- 6. Swan View Subdivision 2025 Replat; KPB File 2025-080  
McLane Consulting Group / Kuiper, Hummel  
Location: Otter Trail off the Sterling Highway  
Sterling Area**

SWAN VIEW SUBDIVISION 2025 REPLAT  
REPLAT OF TRACT 1 AND 2 SWAN VIEW SUBDIVISION (KN74-44)

**ITEM #6 - PRELIMINARY PLAT  
Swan View Subdivision 2025 Replat**

**STAFF REPORT**

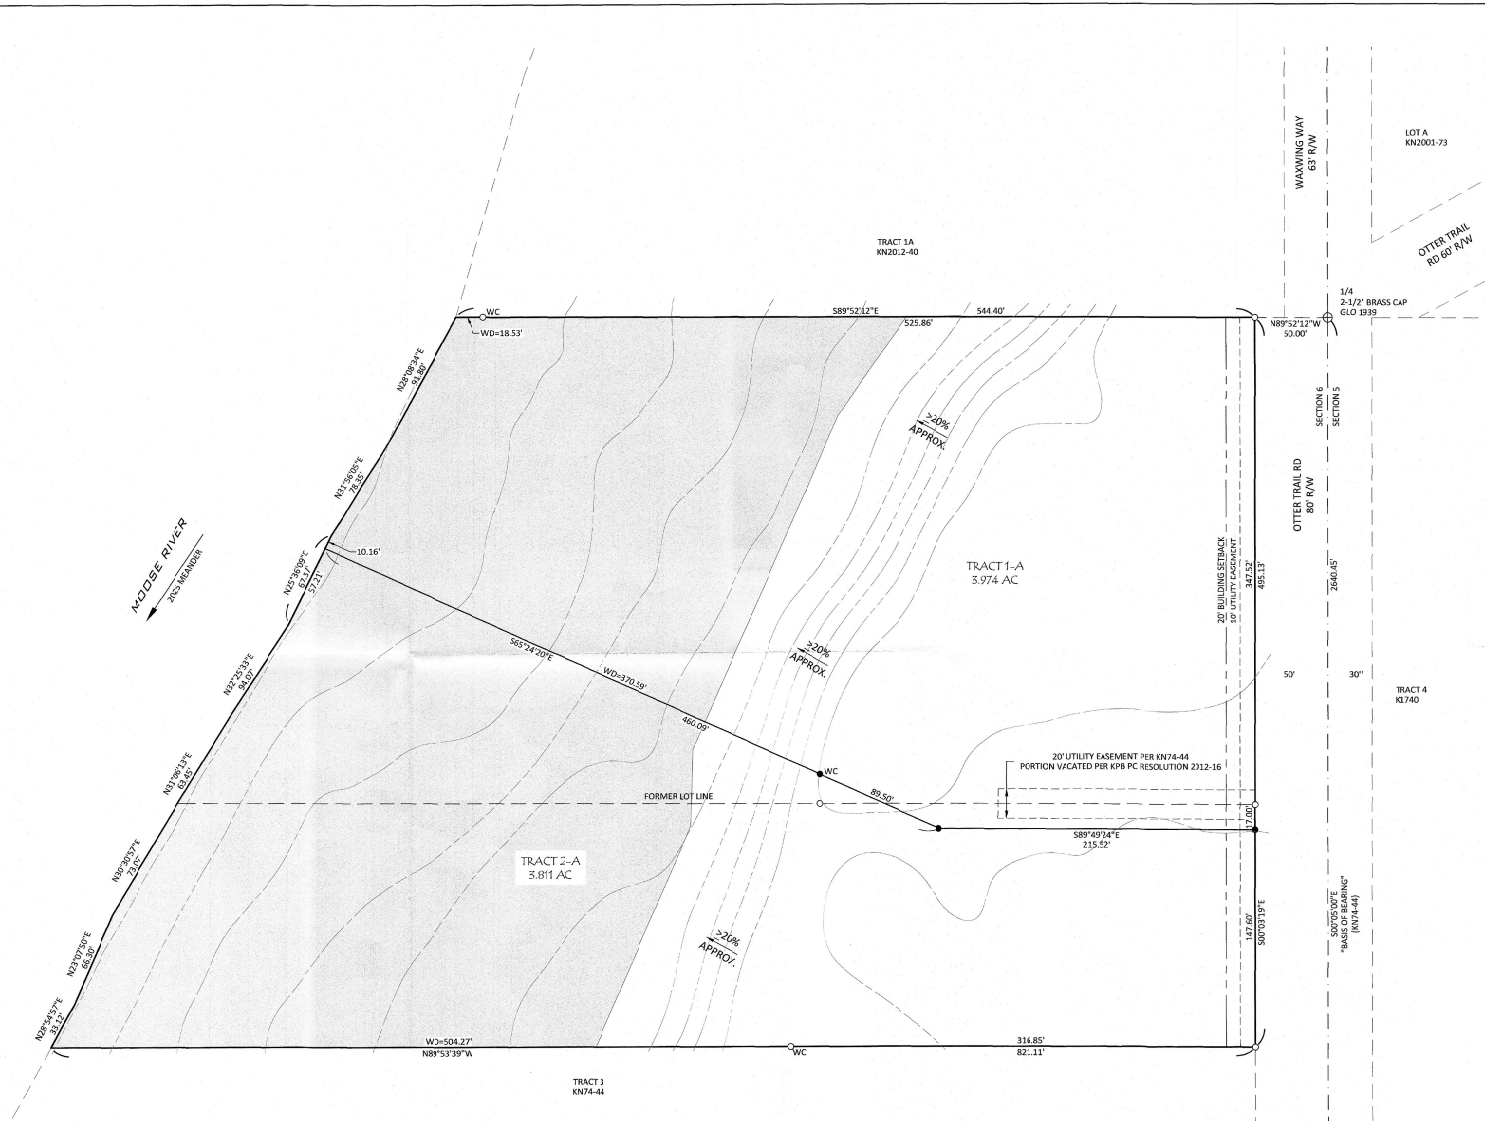
The plat is affected by a section line easement on the east side in Otter Trail Rd. **Staff recommends** the surveyor verify the section line easement and identify the limits of the SLE on the drawing.

The River Center review has identified the plat to be located in a FEMA flood hazard area. The note in KPB 20.30.280(D) is included on the plat, the FEMA Panel and flood zones, need to be included in the note and depicted on the plat drawing.

There appears to possibly be encroachment issue on the north line of Tract 1-A as per the KPB GIS information. **Staff recommends** the surveyor watch for issues when doing the field survey for any issues and note them to staff and land owners along with how they plan to rectify the issues if found.

The 20' Utility easement from the parent plat is being carried forward on the joint line between Tracts 1 & 2. The rear portion was vacated by PC Resolution 2012-16 retaining the front 175' as shown. **Staff recommends** the note be revised to change 'vacated' to 'retained' per KPB PC Resolution 2012-16.

Add Judy A. Hummel as an owner in the Title Block and under the Certificate of Ownership and Dedication. Modify the KPB File No to 2025-080

On diagonal part of Otter Trail Rd, move Rd to the first line behind Trail.  
Label the limit of the section lien easements on the drawing

Flag in Otter Trail Rd to the diagonal portion on the map

Revise the joint easement on the former line of Tracts 1 & 2 as this portion is retained by the resolution.

Identify any encroachments and note solution.
